Immingham Green Energy Terminal Green Hydrogen Production Facility

Environmental Permit Application Duly Making Response Application Reference: EPR/VP3425SV/A001

60673509-ACM-XX-00-RP-IGET Duly Making Response-R01

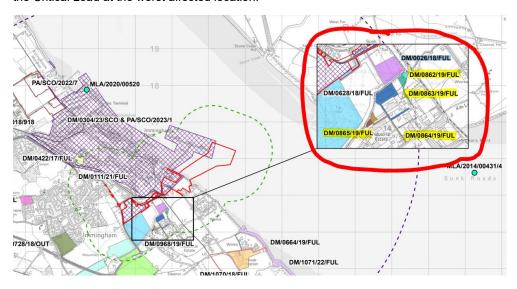
- a) How have the cumulative effects of the "proposed" gas fired power generators (as referred to in Q2) been considered within the cumulative effects of Air Emissions and Noise for this proposal?
 - In the event that there is a technical connection with the proposed gas fired power generators, and fall within the scope of installation (e.g. same operator, or multi-operator installation) then these would be considered together as a single installation / combined impacts.
 - In the event that there is not a technical connection (and not part of the Installation) these would be separately permitted sites. You should justify the cumulative effects (such as assessment of incombination effects, including air emissions and noise) whereby these are proposed facilities (i.e. none operational) and their emissions will not form part of background data.

This was considered during the DCO Environmental Statement. The peaking plant sites are highlighted in the image and the cumulative assessment text is presented below.

References to technical connections have been removed and section 1.3.9 has been added to the supporting statement to re-iterate that there are no plans for technical connection under this permit and an updated permit will be submitted in the future should circumstances change.

The cumulative effects and in-combination assessment has been undertaken as part of the DCO, referred to as the Cumulative Effects Assessment ("CEA").

The contribution of the peaking plant sites is minimal at the sensitive habitats and the in-combination effect <1% of the Critical Load at the worst affected location.
